Subject: URGENT - Parliament Hill School Tree Works - Poplar trees are incorrectly labelled in the site plan. Risk of healthy poplar tree being felled/reduced to 3M in error

I live in 47 Clevedon Mansions, Lissenden Gardens directly opposite and overlooked by the "new block" at Parliament Hill School. I am writing with regards to the planned tree works at Parliament Hill School (2022/4025/T).

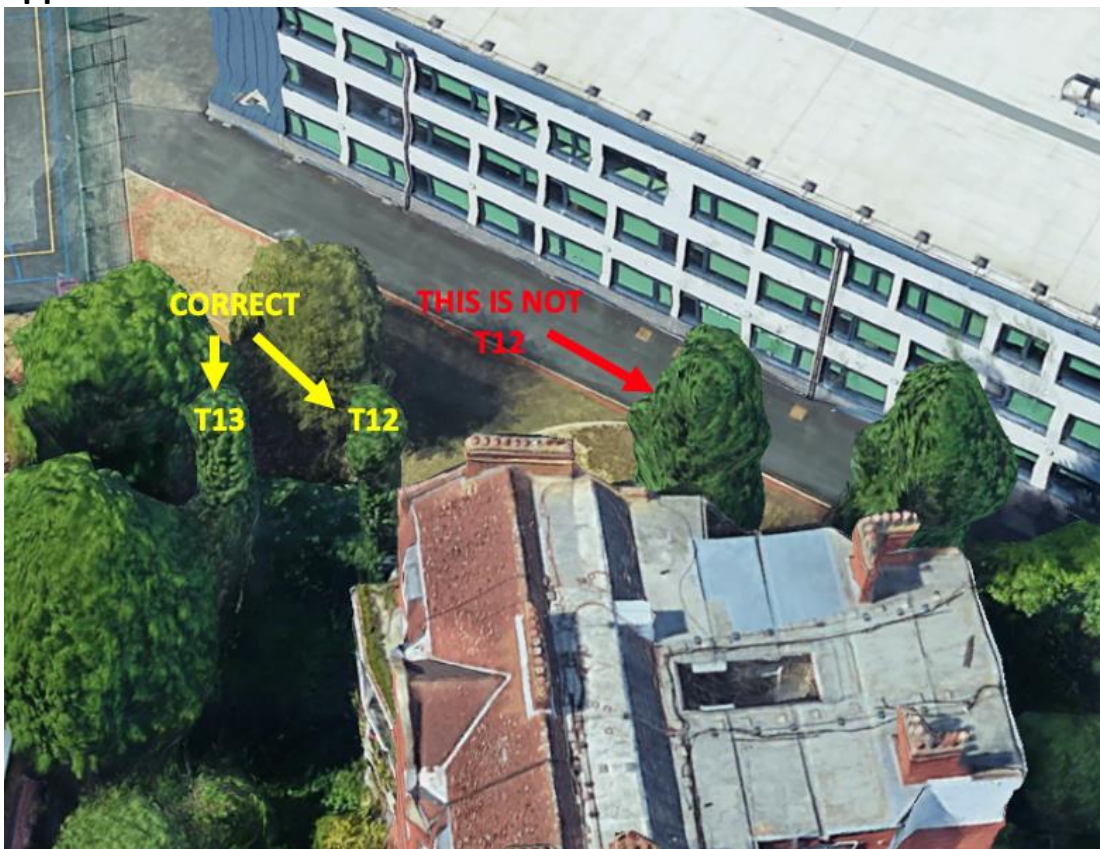
Having reviewed the application, I have noticed that trees T12 and T13 have not been corrected labelled in the site plan.

On the site plan poplar tree T12 is incorrectly labelled. If you refer to the Proposed Works spreadsheet (attached) you will see T12 is noted as the 3rd tree in the row, which is correct as this is metres from our balcony and is indeed 50% dead (two stems, the trunk is thriving). You can see below that it is the second poplar tree labelled T12 in your plan, not the third poplar tree.

This means that in the plan, the tree labelled on your plan as T13 is in fact T12, and the poplar tree to the left (not marked on the plan) of what is currently marked as T12, is actually T13. I have looked at the photos of the trees, and the photos of T12 and T13 are not those labelled in the plan.

Can this please be corrected urgently so a healthy tree (i.e. that incorrectly labeled as T12) is not reduced to 3M or felled in error. The poplar trees have

I would also like to speak to someone with regards to these two trees as reducing to 3M seems extreme. Can T12 not just have the dead trunks removed as they are spurs? This will leave the core trunk intact. If it does still need to be reduced, why 3M? This is very extreme. Surely more of the tree can be saved? Again, with regards to T13 how large is the cavity? It does not look that large in the photo and would seem to be the result of a failed stem. Trees very often survive with no loss of stability with a cavity such as this. How high is the cavity? Can this not be monitored for longer? I see the tree everyday and in the strongest winds, and it is stable.
